**APPENDIX A**  
**THE HYDROGEOLOGIC FRAMEWORK MODEL/  
GEOLOGIC FRAMEWORK MODEL INTERFACE  
(RESPONSE TO USFIC 5.10)**

### **THE HYDROGEOLOGIC FRAMEWORK MODEL/ GEOLOGIC FRAMEWORK MODEL INTERFACE (RESPONSE TO USFIC 5.10)**

This appendix provides a response for Key Technical Issue (KTI) Unsaturated and Saturated Flow Under Isothermal Conditions (USFIC) agreement USFIC 5.10. This KTI agreement relates to providing more information about the apparent discontinuity between the geologic framework model (GFM) and the site-scale hydrogeologic framework model (HFM).

Figure A-5. Vertical Thickness of the Tram Unit in the HFM

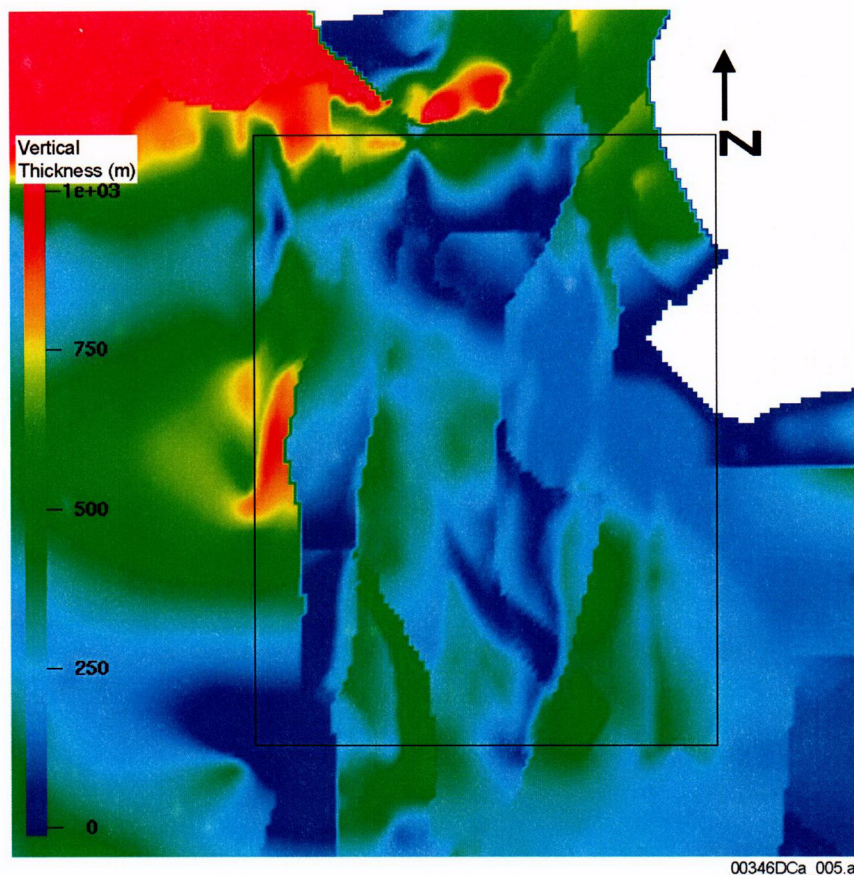
In the Tram Tuff, a large discontinuity was identified in the northwest corner of the GFM area. In this area, the Tram Tuff pinches out to zero thickness in the GFM, but it becomes thicker in the HFM. This can be seen in Figure A-5 as an abrupt change in color (straight, north-south line in northwest corner and intersecting the upper horizontal portion of the white box signifying the GFM area) where the HFM shows a thickness of about 1,000 m and the GFM shows a thickness of about 350 m.

This apparent discontinuity was identified (Wilson 2001), and Yucca Mountain Project personnel worked to ensure that units common to both models were handled in a uniform manner. The discontinuity was resolved within the HFM by adding contours with increasing elevation to the GFM and by continuing this incline in the HFM definition, resulting in a smooth transition from the lower Tram tuff thickness in the northeast corner to the greater thicknesses seen towards Claim Canyon Caldera and beyond the GFM boundaries. The current version of the HFM, HFM 2002 (DTN: GS021008312332.002), is consistent with data from boreholes and is consistent with the current version of the GFM (GFM 2000; BSC 2002). The smooth transition enhances

Figures A-5 and A-6 show the thickness of the Tram Tuff unit. HFM 2002 (Figure A-6) shows a smooth transition from the GFM-defined thickness to the area outside of the GFM. In general, HFM 2002 shows fewer anomalies (e.g., trenches and peaks). These features normally do not show up in 500-m computational grids, but they are addressed and resolved in HFM 2002 to create a smoother surface.
